1 **Distribution**

2
3 **Q. Reference: "2025 Capital Budget Application," Newfoundland Power Inc.,**
4 **June 28, 2024, sch. B, Distribution Feeder Automation, p. 12.**

Figure 2 – Location of New Reclosers for PUL-03.

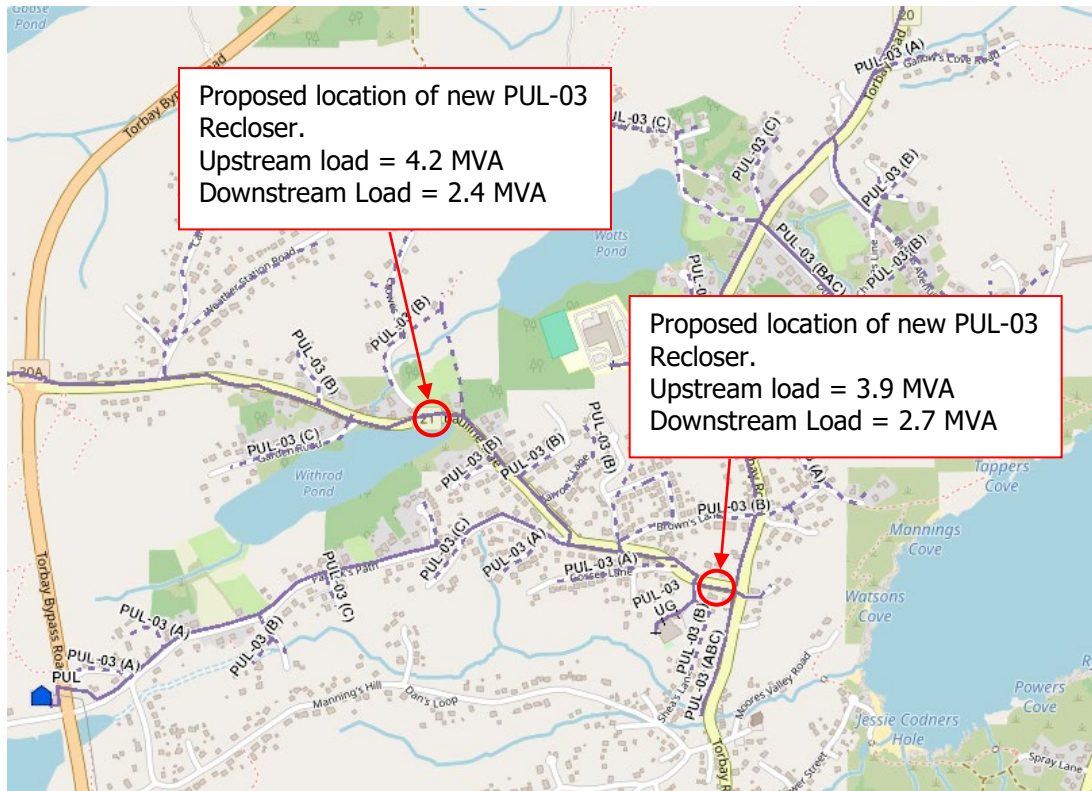
15 **b) For feeders PUL-02, PUL-03 and LOK-01, please provide the single line**
16 **drawings with the proposed recloser locations and upstream/downstream**
17 **load values.**

- 1 Figure 2 shows the locations of the newly proposed reclosers for PUL-03, as well as
- 2 the requested upstream and downstream loads. Total feeder load is approximately
- 3 6.6 MVA.
